STAFF REPORT
COMMUNITY DEVELOPMENT DEPARTMENT

HEARING DATE: April 28, 2022
 TO: Planning & Zoning Commission
 FROM: Joseph Dodson, Associate Planner
 208-884-5533
 SUBJECT: H-2022-0004
 Alamar Subdivision

LOCATION: The site is located at 4380 W. Franklin Road (Parcel #S1210346603), near the northeast corner of N. Black Cat Road and W. Franklin Road, on the north side of Franklin Road, in the SE 1/4 of the SW 1/4 of Section 10, Township 3N, Range 1W.

C. Landscape Plan (dated: March 15, 2022)

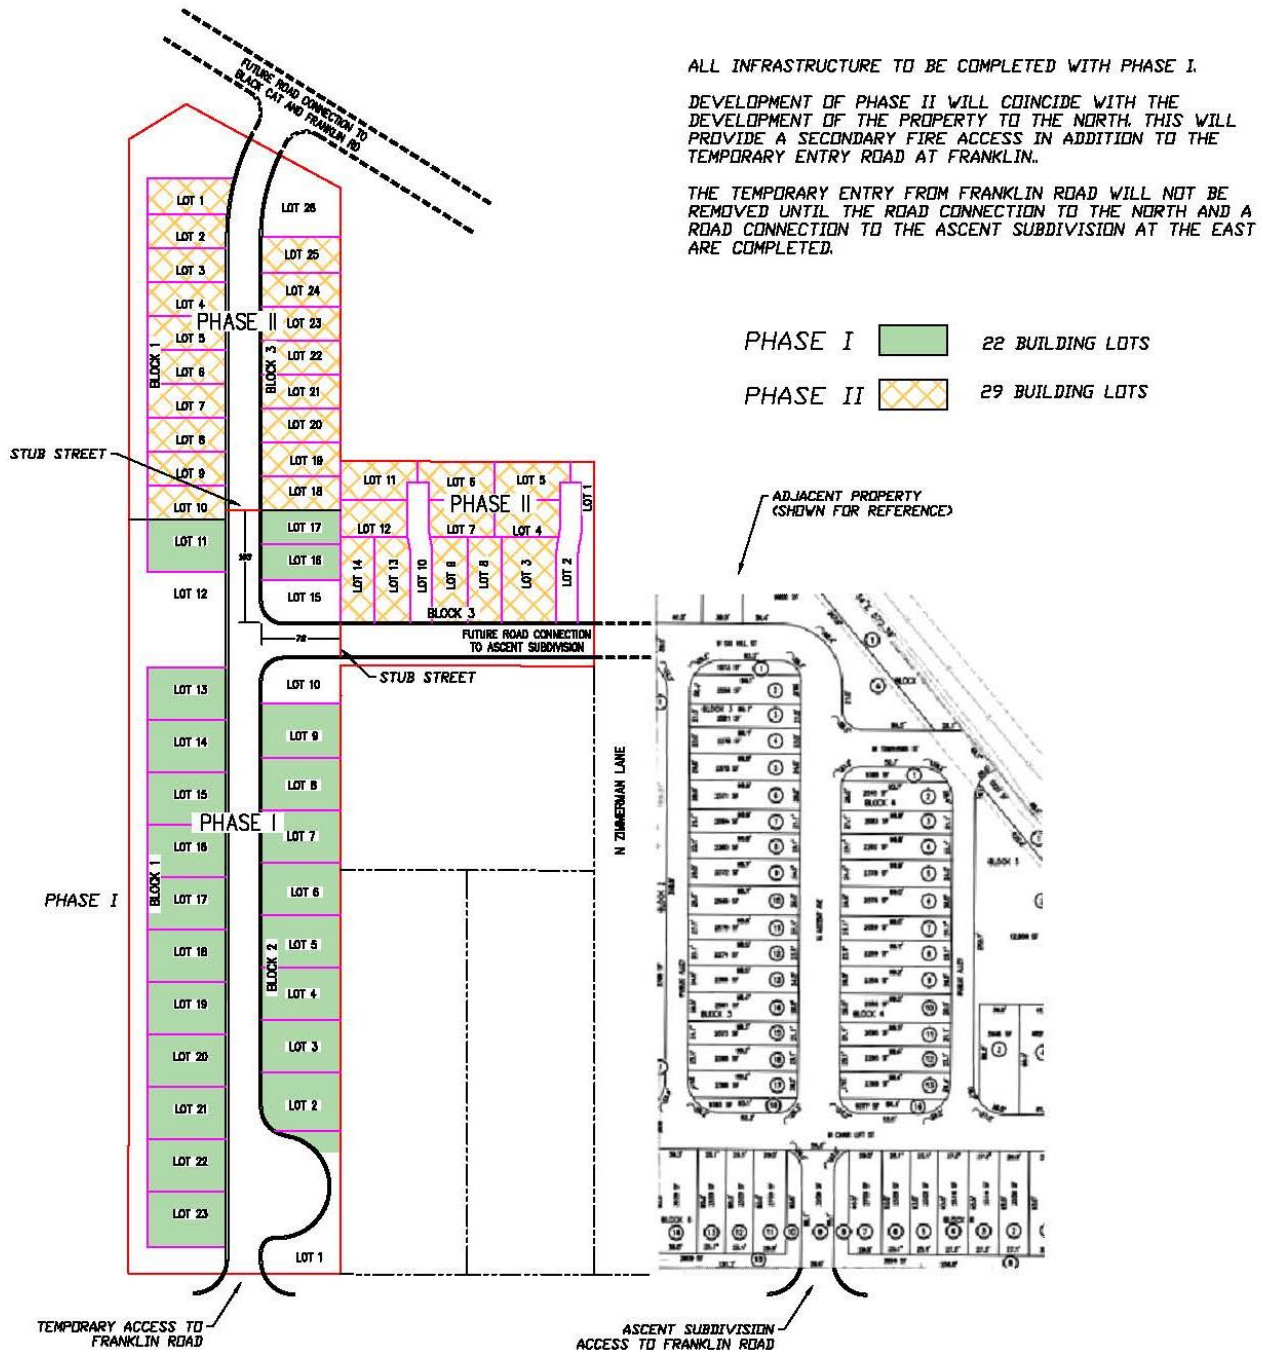
According to the submitted landscape plan, some trees are included in the common open space areas where there is no storm drain retention areas. These retention areas are shown to be vegetated with grasses which complies with UDC 11-3A-11 and is allowed to qualify towards the minimum qualified open space for the project. Staff is recommending the most central tree in the centralized open space lot (Lot 12, Block 1) on the west side of the project be removed so a larger area of usable grass can be proposed in this lot. Further analysis on landscaping and open space qualification is in the next section below.

- b. Add data to the landscape plans showing compliance with UDC 11-3B-7C for the proposed parkways.
 - c. Remove the most central tree shown in the center of the centralized open space lot within Lot 12, Block 1 to add an area of openness in the center of this lot.

9. The submitted landscape plan, dated March 15, 2022, shall be revised prior to the first final plat submittal, unless otherwise noted:
 - a. Depict the revisions outlined in Condition VIII.A.2.
